## TECHNICAL and SERVICE BULLETIN

No: 16

# NEW CHIEF BRACKETS DESIGNED WITHOUT ECCENTRICS

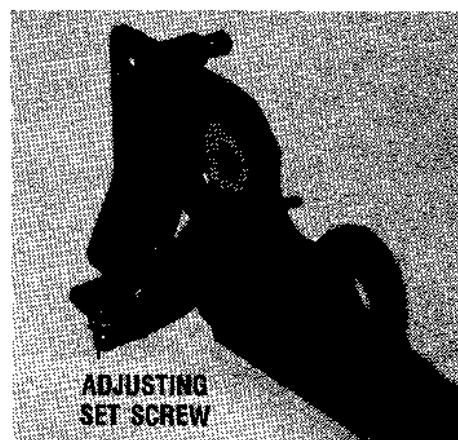
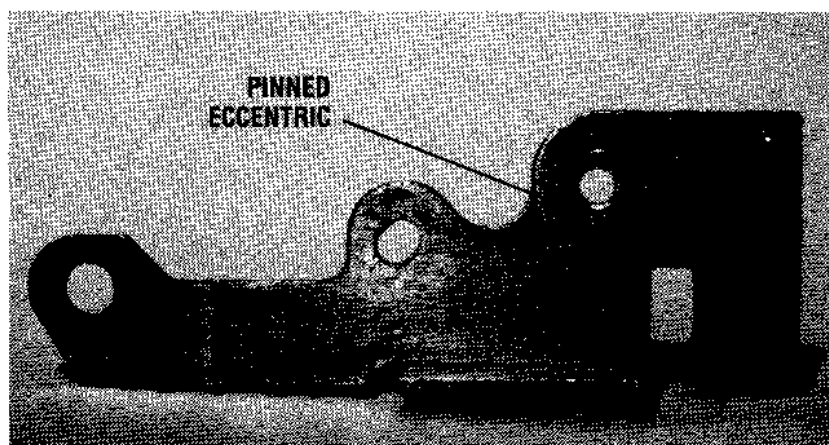
Graph Tech has redesigned the mounting brackets for the Kompac Model AF 17 and 17G. The first lot of brackets have been reworked and will have the eccentric pinned in place. The next lot will be a solid bracket with 2 holes for mounting. The AF 15 and 15G brackets will be available later in the same version.

The new procedure for adjusting the Kompac form roller stripe now eliminates turning eccentrics. The set screw at the end of the bracket foot now adjusts the form stripe. Turning the set screw clockwise causes a lighter stripe. Turning the set screw counter clockwise causes a heavier stripe.
